**REMARKS**

• AMENDMENT UNDER 37 C.F.R. § 1.111  
U.S. Application No. 10/076,423

Q68513

Fig. 8

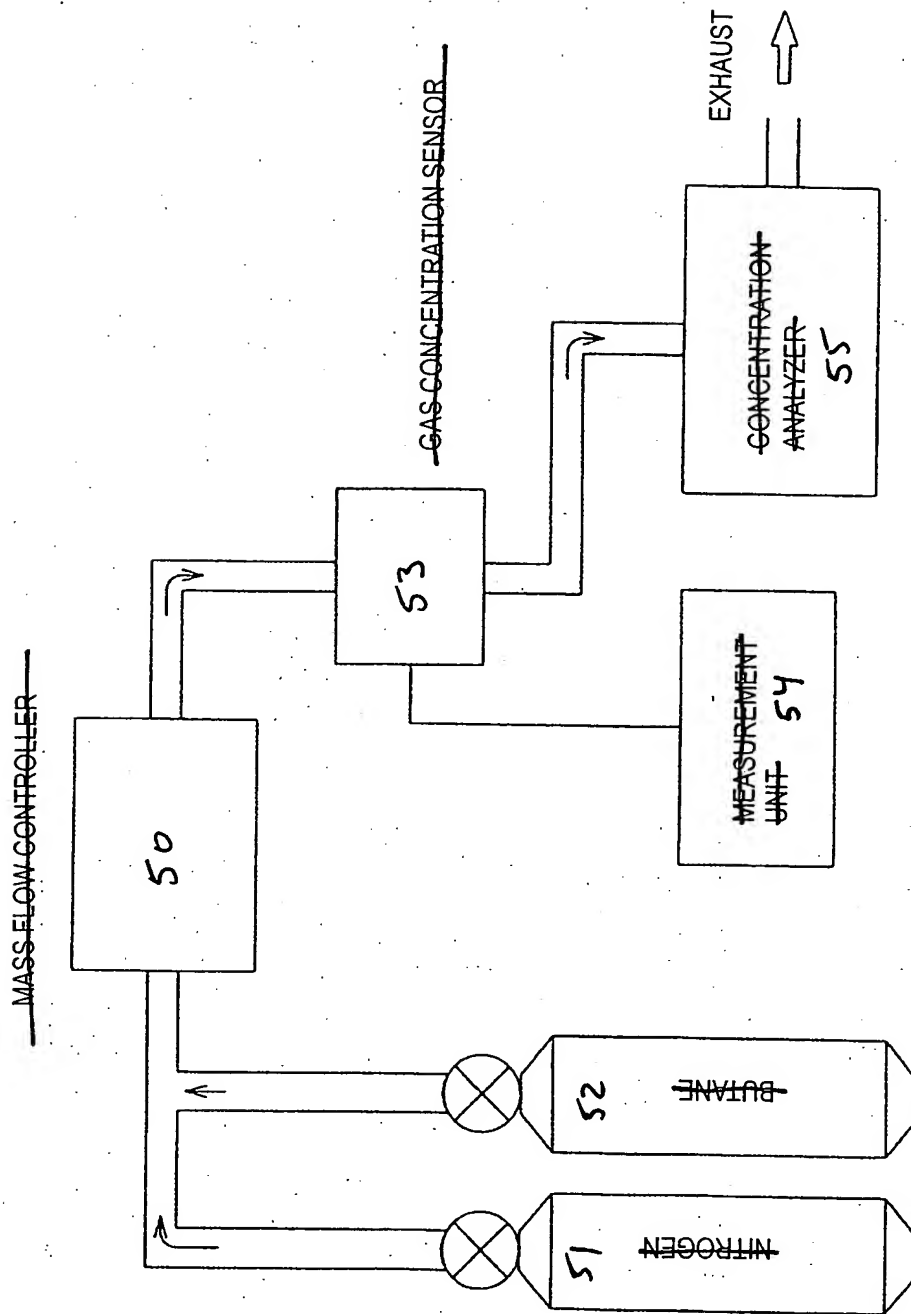
In response to the objection to Figure 8, Applicants submit herewith proposed drawing corrections (with changes marked in red ink), where the block elements have been labeled with reference numbers. Corresponding changes have been made to page 21 of the specification.

Applicants will submit corrected formal drawings upon approval by the Examiner.
